From: Milbrath,Susan <milbrath@flmnh.ufl.edu>
Sent: Thursday, May 16, 2024 2:51 PM
To: Leslie McLendon
Cc: Barbara Henry; jcauthenmd@aol.com; Jay Fowler
Subject: Re: Town of Tioga - South Annex
Attachments: SingletonTiogaOffsetPlan.pdf

**Alachua County
Development Review Staff
Insufficient Application Report**

Project Number: DR23-000003

Preliminary Development Plan for Town of Tioga South Annex

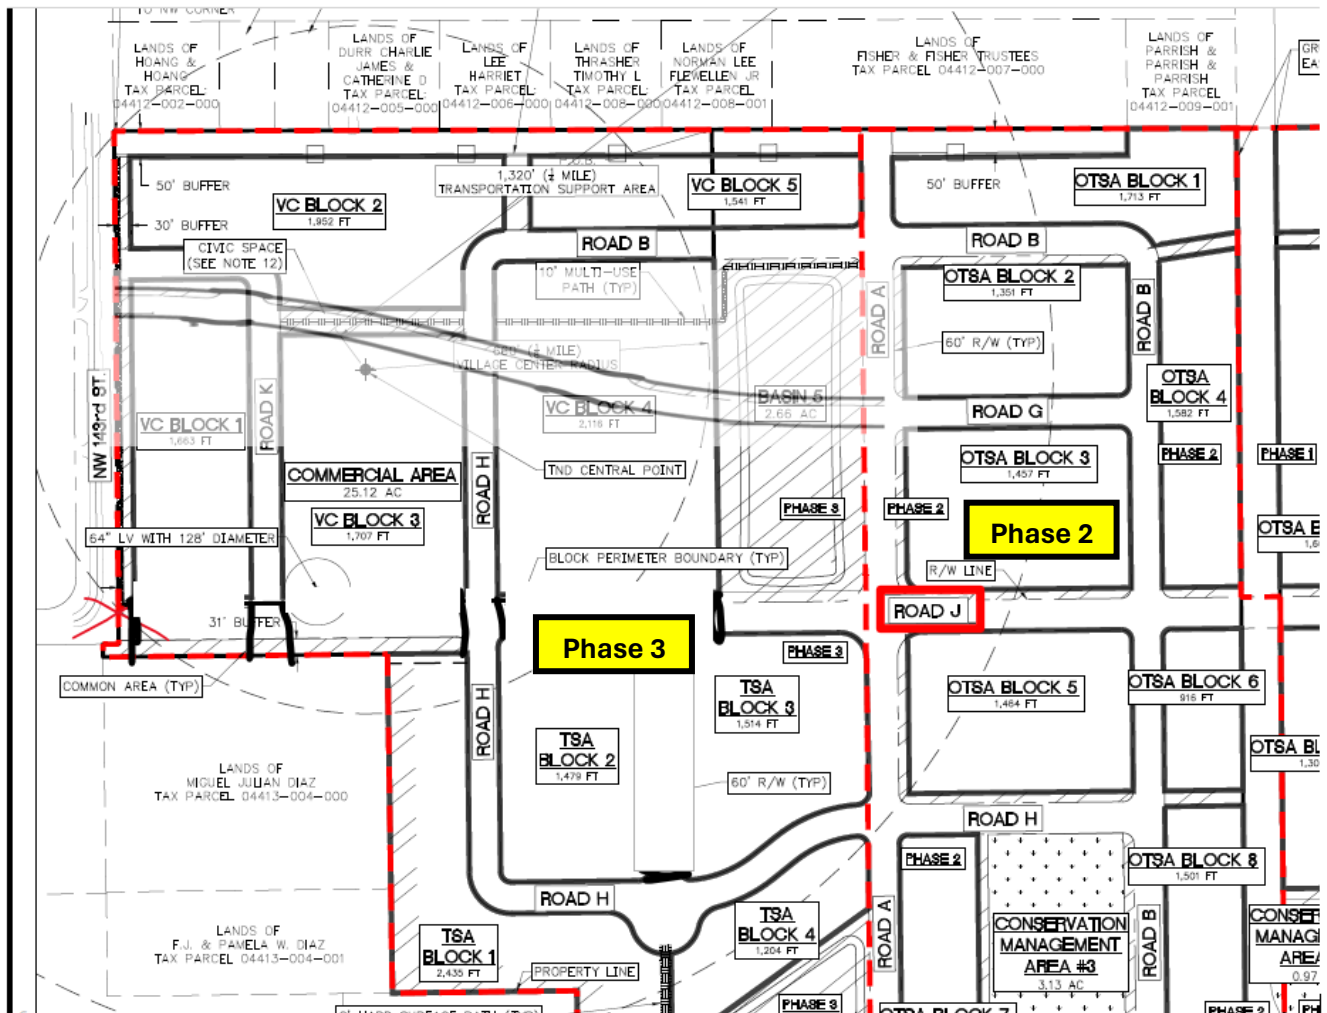
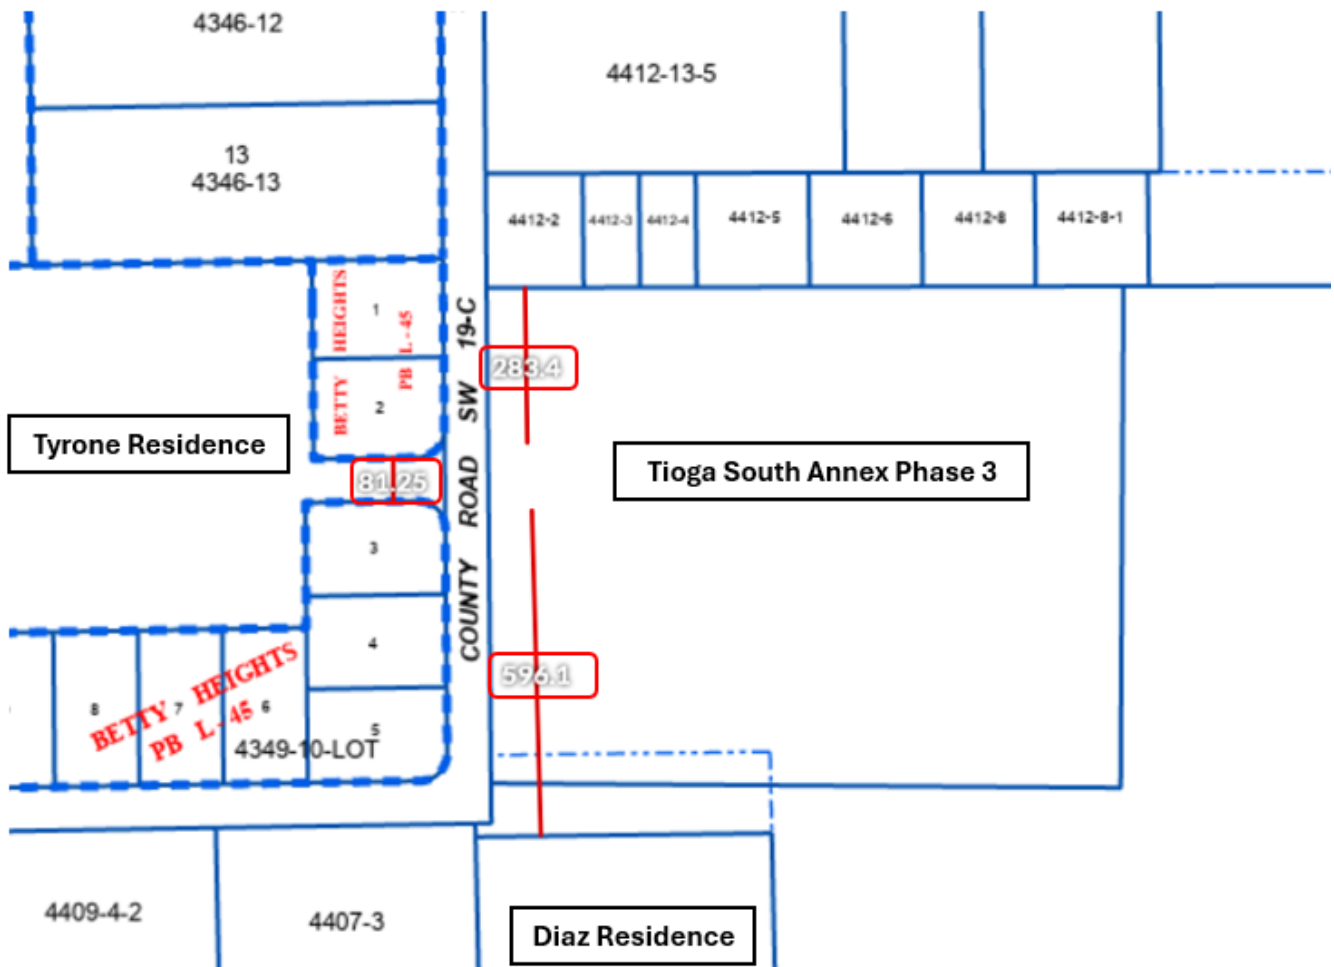
- I would push to have Road J curve to the north to achieve the “Tyrone Offset” connection instead of connecting to Road G as shown below. Aesthetically, an “S” curve will work to:
 - Slow down any thru traffic within the development instead of having a long straight away. Example of bad design is SW 17th road in Grand Oaks at Tower connecting SW 24th Avenue with SW 75th Street....It’s becoming a raceway.
 - Breakup the site line through the development as one is driving, biking or walking down the street. It will encourage more northerly ADTs through the northern access connections previously mentioned.
 - Assuming that Phase 3 is to be developed last, request early planting of adequate trees and landscaping to break up the site line giving time for more established vegetation when the time comes to complete the development that the landscaping isn’t merely “twigs in a cow pasture”.

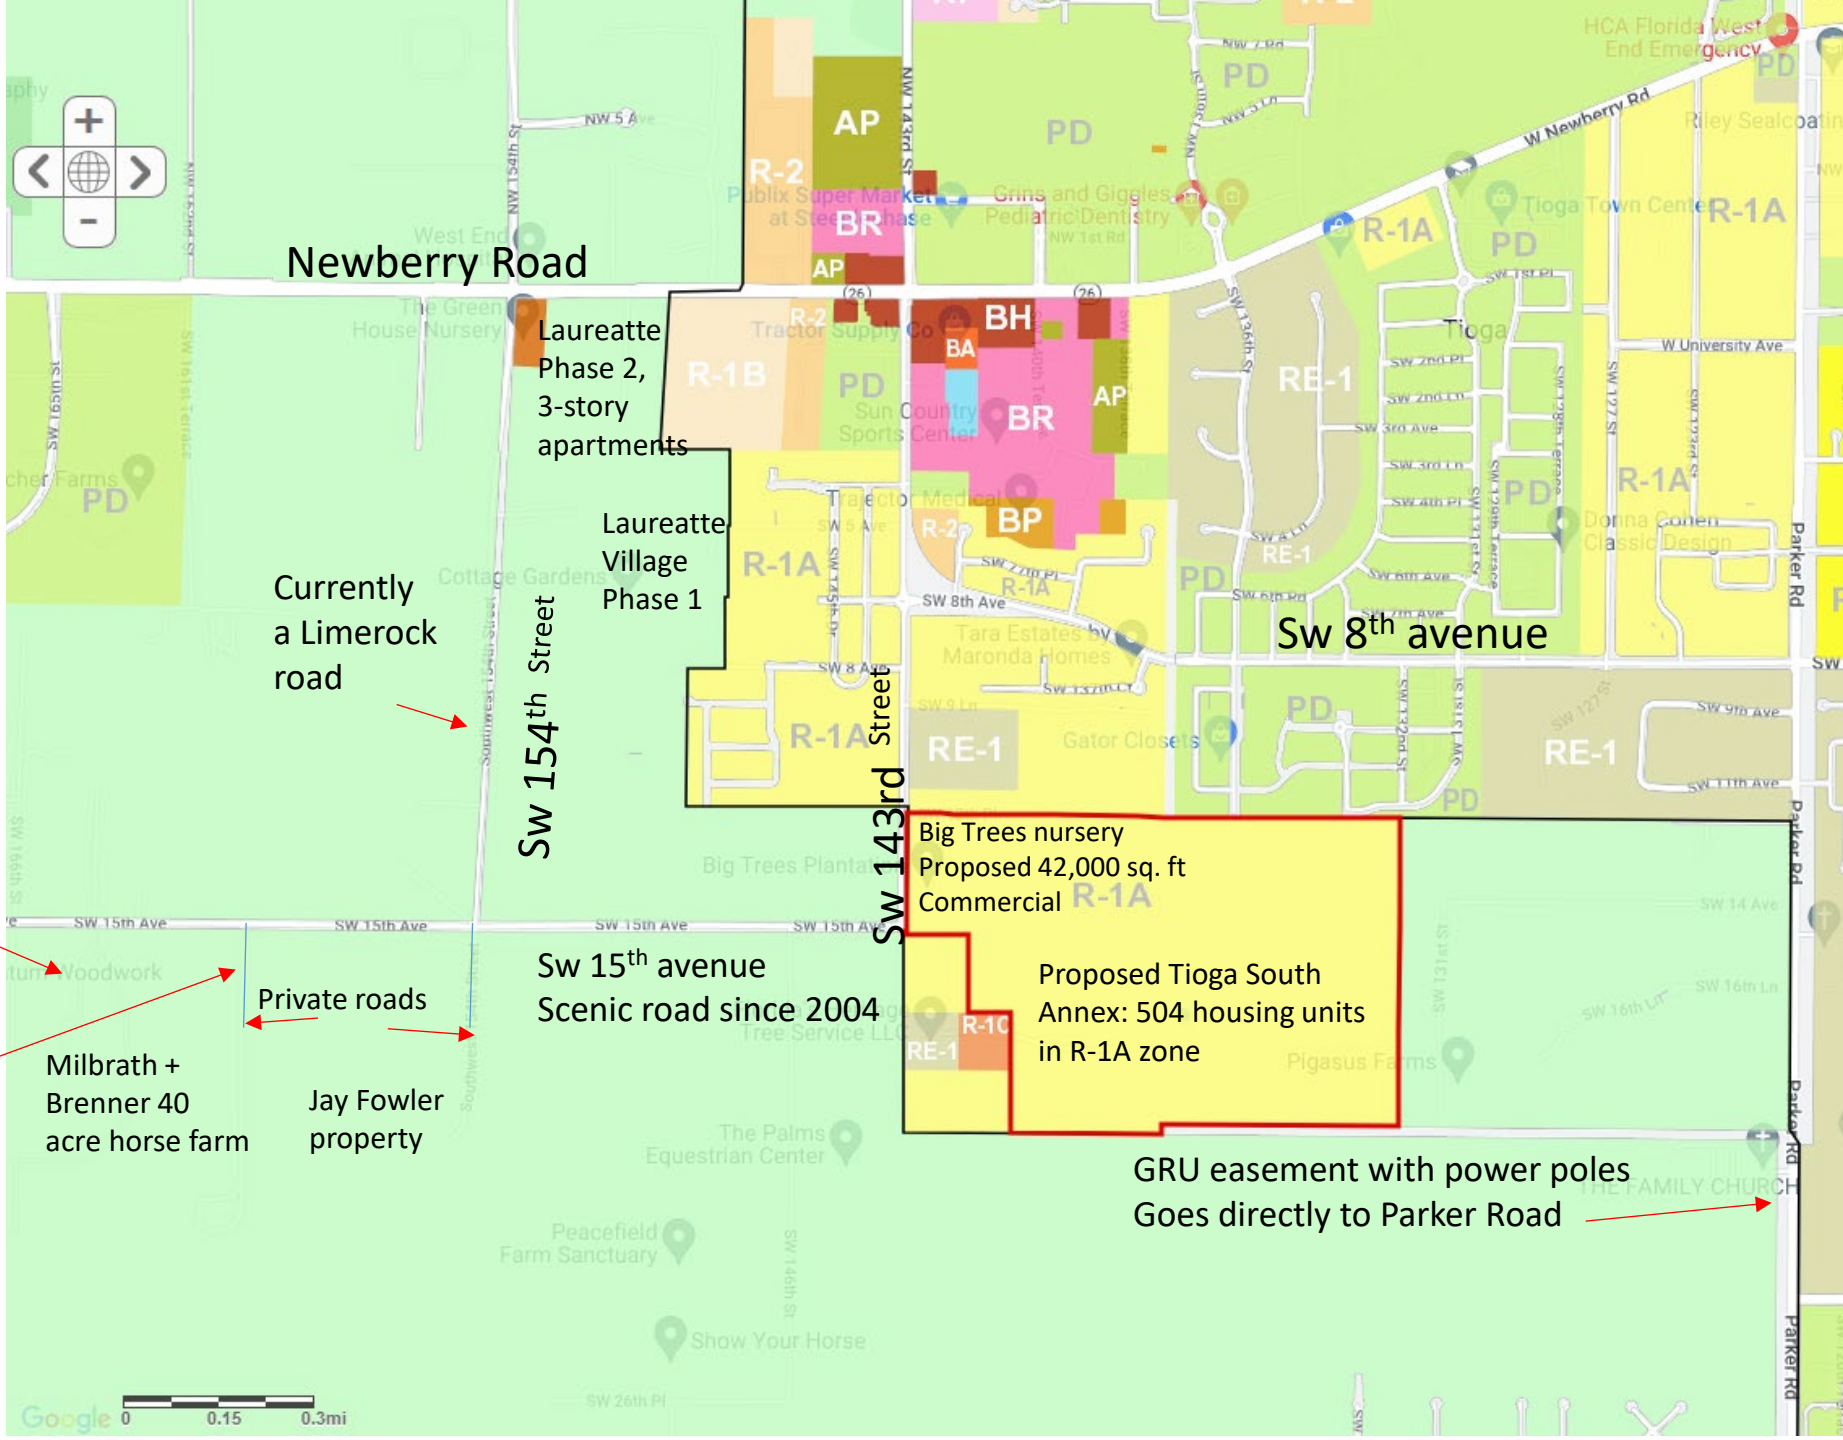
1) The commissioners are very sympathetic, but the 200+ acres are already R-1A zoning (see red outlined area on yellow and green map attached). This allows up to 4 houses per acre. As Anna did the calculations, she noted the Diaz development could throw in their two houses south of the tree farm in the mix, and another small property that is adjacent, and legally would be allowed to build over 880 units total. They are asking for 504 units at this point, but that doesn't mean they won't ask for more later. Also, it is not clear whether the apartment buildings in the Village Center part of this original request for 504 units.

3) SW 15th avenue is indeed part of the green belt but is just on the edge. Barbara Henry's property is within the "urban cluster" and strangely the county map seems to extend the black line designating the urban core south to include the Diaz property (also outlined in red), even though it is R-1A zoning. Anna was surprised to see the line defining the urban cluster jagged south. We need to find out why. I plan to make a request for public records relating to the Jonesville Activity Center (which is I believe is the same as the urban core). This was not my understanding of the boundaries when I bought multiple properties beginning back in 2003.
